Normal Neighborhood Working Group - Meeting September 18, 2014

Normal Ave. Neighborhood Comments: page 1/3

Normal Neighborhood Plan Working Group Alternative Discussion Draft

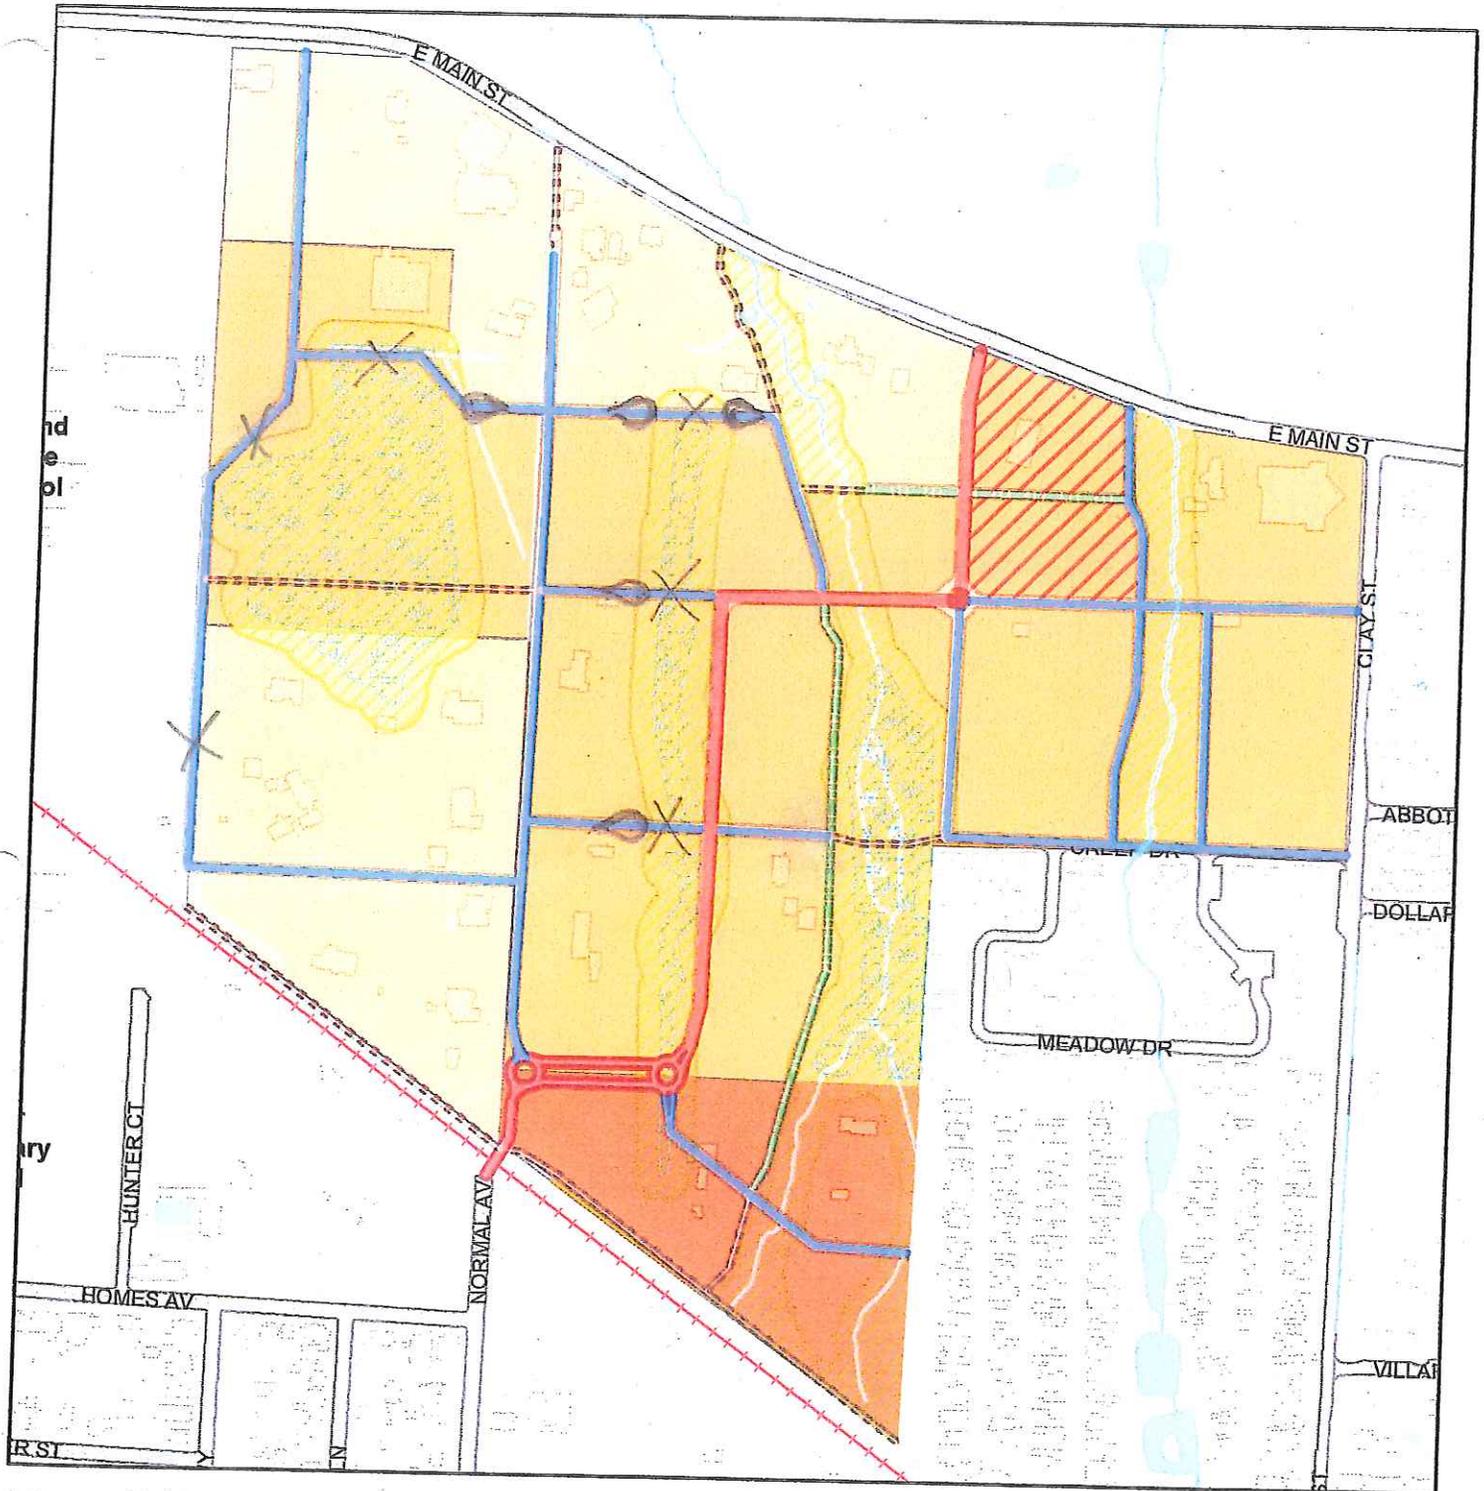
We agree that the interior of the Plan area - along the New Normal Collector Road, should be zoned as NN-1-3.5 with a maximum density of 7.2 DU (dwelling units) /acre. **HOWEVER, reclassification along existing Normal Ave, should be reduced from NN-1-3.5 to NN-1-5, with a maximum density of 4.5 DU/acre**, as given in the Greene Subdivision, since prior construction, in this area of large lot/single-family residential homes, already exists as well.

We agree with the **elimination of the shared street adjacent to the center wetlands**. Access to housing will be adequately provided by the New Normal Collector. We agree that the **Old Normal Ave. should NOT extend** beyond its current terminus **and NOT connect with E. Main St.** This would not only be a dangerous egress onto a blind curve, but it would detract from the quality of the current rural neighborhood with cut-through traffic zooming by established residences.

a. **Straight Cut-Through N-S Connector** - Any straight through connecting street would produce a high volume of traffic that would be utilized by more than any development in the Normal Plan. Many reasons make this a barrier to our agreement with the Plan. Firstly, traffic would egress onto E. Main St. at a blind curve. Secondly, the widening that would be required for the traffic load would encroach onto already existing buildings, yards and set-backs. Thirdly, the neighborhood walkability and safety would be greatly reduced by random cars ignoring speed limits and increased traffic volumes.

b. **Multiple E-W Paved Connectors** - We oppose so many east-west connectors throughout the Plan. If the connectors are truly for the development, then only one to Clay St. and one to Normal Ave. are needed. All other **connections should be to enhance the walkability and neighborhood community**. If the Open Space design actually RESPECTS the natural resource and wildlife corridors/ habitats, then ONLY the New Normal Collector and footbridges should cross over these sensitive areas. Additional access would be available from the main New Normal Collector and small side/shared streets off of Old Normal into the newly developed **cul-de-sac neighborhoods with connections across the Open Spaces by habitat-sensitively designed foot bridges for bikes and pedestrians**. Then, we would truly have safe streets to share with vehicles and pedestrians since there would be no cut-through vehicular traffic, only foot traffic crossing the Open Spaces. East-West local streets would then be aligned with foot paths and connected as a walkable neighborhood.

c. **Density Bonuses adjacent to Open Spaces** - We strongly **disagree with the planning tool of density bonuses, especially adjacent to open spaces**. The Comp Plan (Chapter 8.09.07) specifically outlined the purchase of the natural area, designated Wetland #9, with a capital improvement program way back in the 1980's (Chptr.4.24 -Transfer of Development Rights for Wetlands, and Chapter. 8.16.3- Comp Plan Open Space Policy). Now that a master plan is being developed for these areas, the City should follow through with purchasing options rather than development options that will impact the resource forever. **Development density increases adjacent to natural wetland areas will compact soils to the point of altering aquifer recharge capabilities and retention of seasonal flood waters**, not to mention the effects on the environment, air quality, and habitats.

- a. Survey the property owners for their intent to develop, prior to finalizing the master plan.
- b. Reclassify densities to maintain existing neighborhood character, as well as reduce the zoning densities as outlined on current Normal Plan. Comply with the needed densities as indicated by the 20 year supply indicated in the 2011 Buildable Lands Inventory.

- c. Avoid cut-through roads across farm land, wetlands, and creeks by using cul-de-sac designs and foot bridges to preserve them and preserve the wildlife habitats/corridors.
